66321D-521-01

S E R V I C E N O T E

66321D with Option #521

Reliability Improvement of Instrument

CORRECT J207 PLACEMENT – alignment to within $< 0.3\text{mm}$

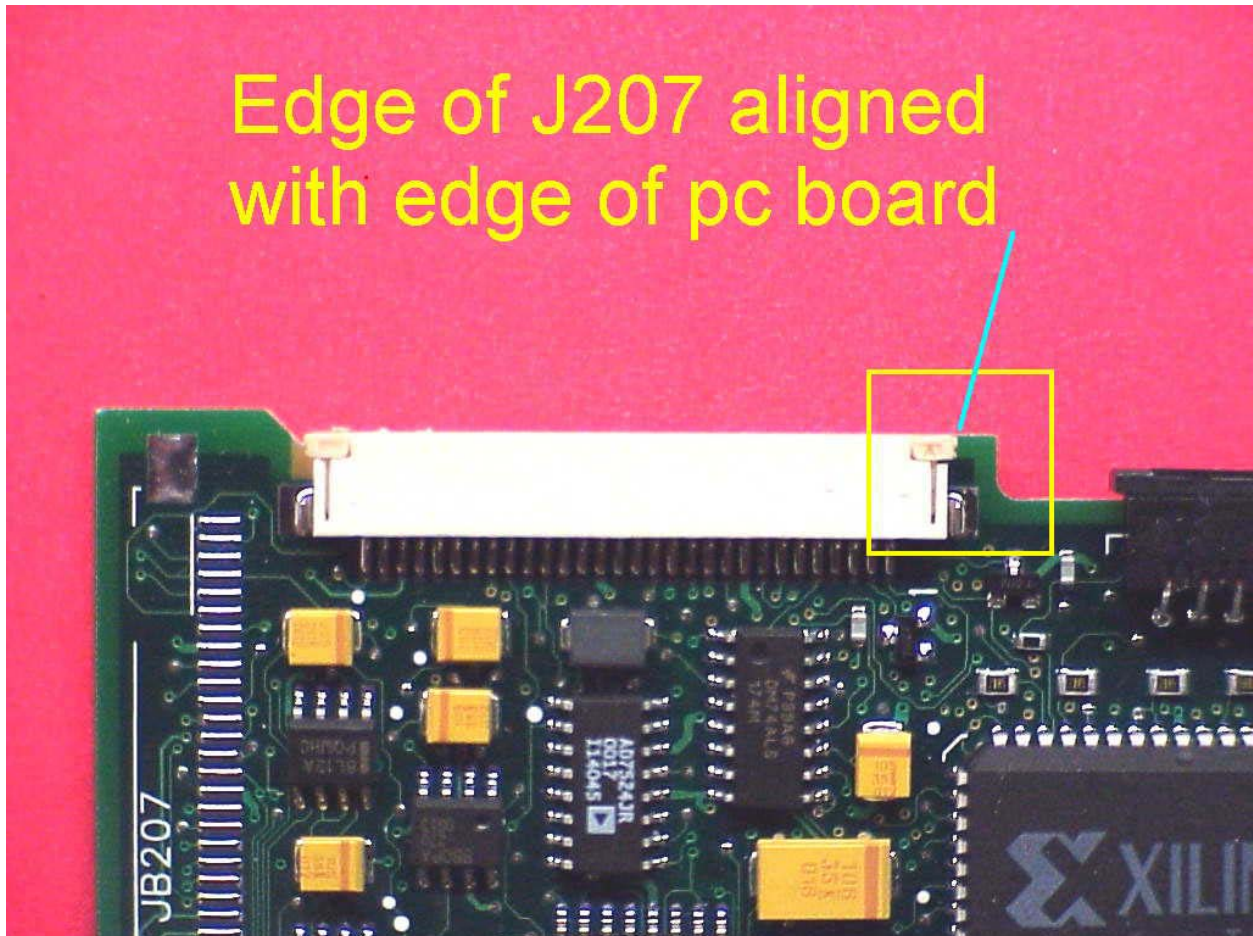
Latent product failure due to misplaced connector J207 on SMT assembly 5064-0018 (GPIB/RS232 interface). Misplacement of J207 could lead to inadvertent contact/shorting of exposed feed-throughs on SMT board. Ultimately, resulting in over-stress of components of damage to SMT board components. Resulting contact could degrade useful life of instrument.

Picture shows connector aligned to edge of SMT board to within $< 0.1\text{mm}$

- 1) Compare placement of J207 to attached photos. Instruments with a “misplaced” J207 should be returned to Agilent for warranty repair.
- 2) Instruments returned to the Service Center for routine calibration should be inspected for this potential defect. Defects should be addressed using Agilent’s unit exchange process with costs being charged to warranty.
- 3) The factory has modified production documentation to include visual inspection and specific electrical testing for this potential short.
- 4) Factory is maintaining feedback to SMT board supplier regarding quality of assembly.

INCORRECT J207 PLACEMENT – misaligned by $> 0.3\text{mm}$

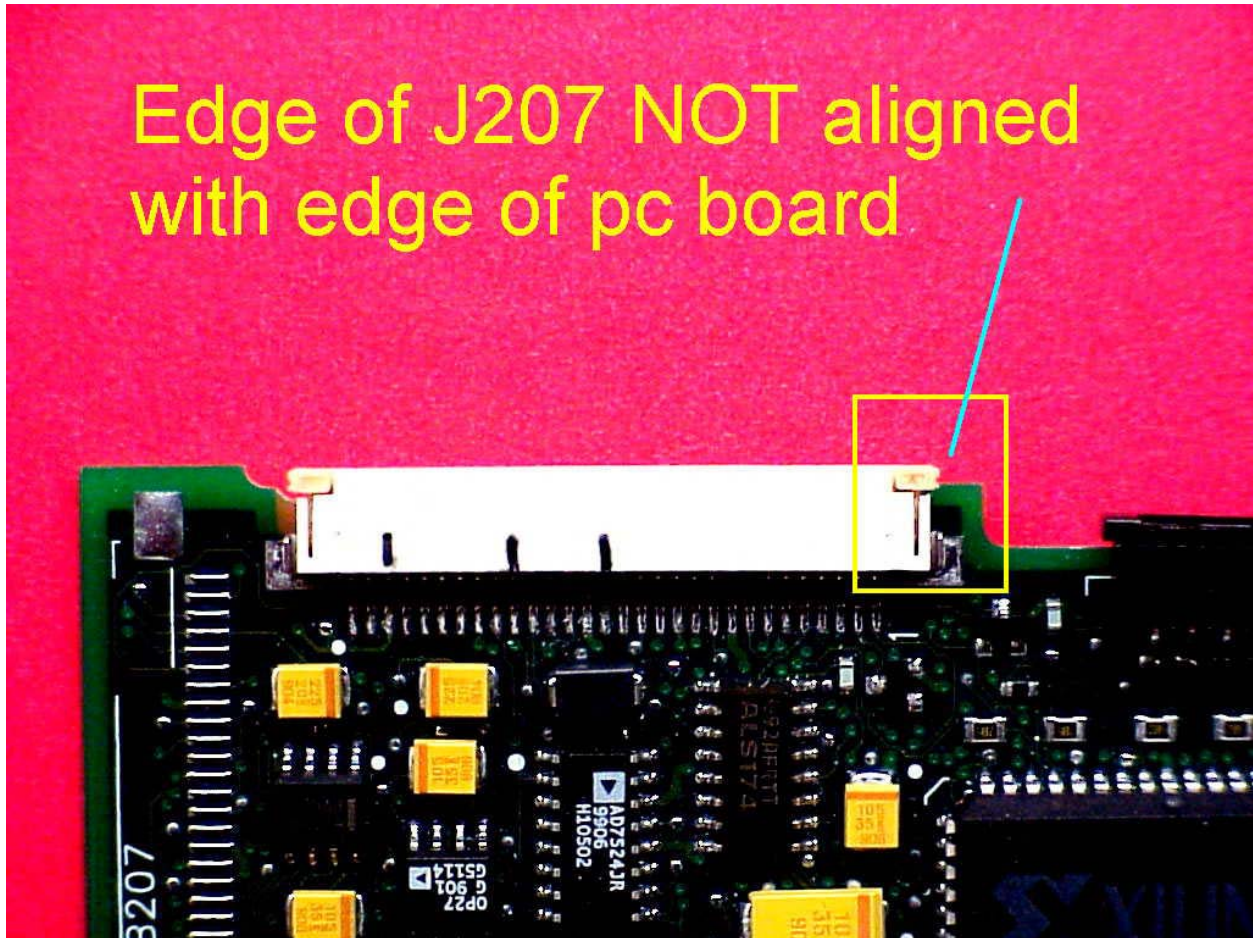
Picture shows connector extending past edge of SMT board by $>1.2\text{mm}$
